Docket No. 50-423
B11456

Reference: (1) W. G. Council letter to B. J. Youngblood, Revised Response to Question 480.9, dated November 30, 1984.

Millstone Nuclear Power Station, Unit No. 3
Discussion of Critical Flow Models Used in Containment Subcompartment Analyses

DISCUSSION OF CRITICAL FLOW MODELS USED FOR
SUBCOMPARTMENT ANALYSIS

FIGURE 1
 COMPARISON OF HEM & MOODY
 CRITICAL FLOW WITH TEST
 DATA AT 17.6 PSIA
 MILLSTONE NUCLEAR POWER STATION
 UNIT 3

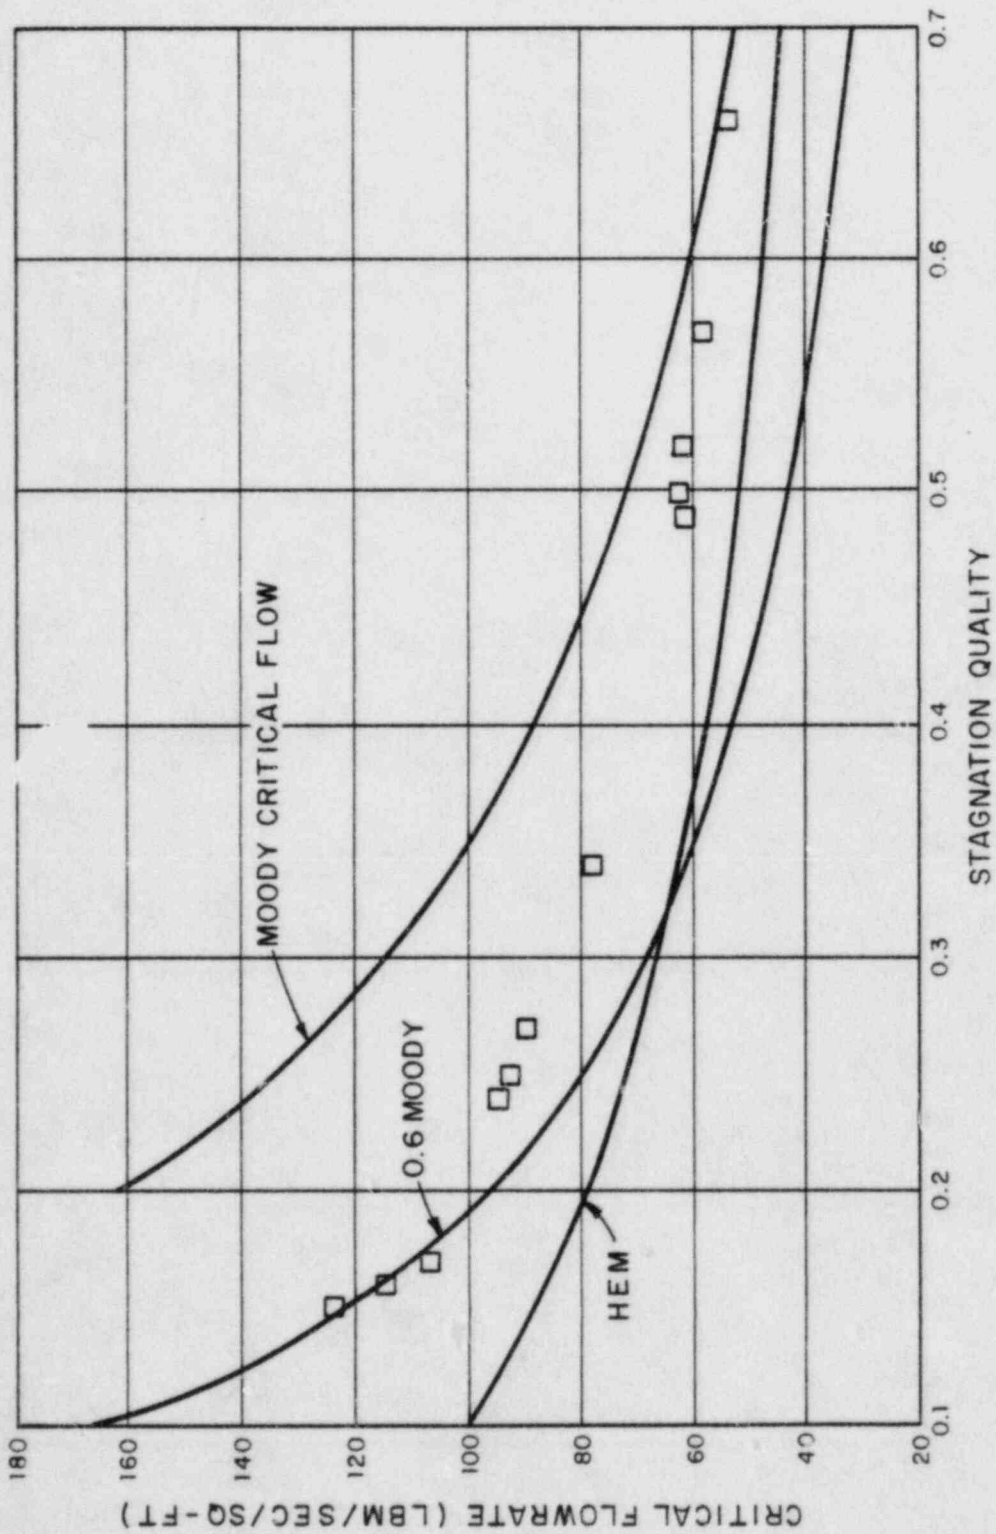
The 0.6 Moody correlation appears inconsistent compared to experimental data and the HEM correlation at the lower upstream pressure (Figure 1). The flowrates are slightly overpredicted at low quality, and underpredicted at higher quality. At higher pressures, (Figure 2) and especially at higher qualities, HEM and 0.6 Moody critical flowrates are similar with HEM being slightly more conservative.

The peak pressures calculated in the pressurizer and steam generator subcompartments are more closely represented by the data shown in Figure 1. Since the flowrates from the breaks in both subcompartment models are relatively low, a significant amount of air occupies the subcompartment volumes up to the time of peak pressure. It is stated in the subcompartment analysis procedures (Gido 1979) that the presence of air plays an important role in the subcompartment analysis. Further, the HEM correlation is recommended since it models the presence of air in the nodes.

In every case the HEM correlation is conservative compared to the experimental data. In addition, both Henry and Ardron suggest that HEM shows good agreement with experimental data and consistently provides a lower bound to all data reported. Accordingly, the HEM correlation was selected for use in the Millstone Unit 3 subcompartment analyses.
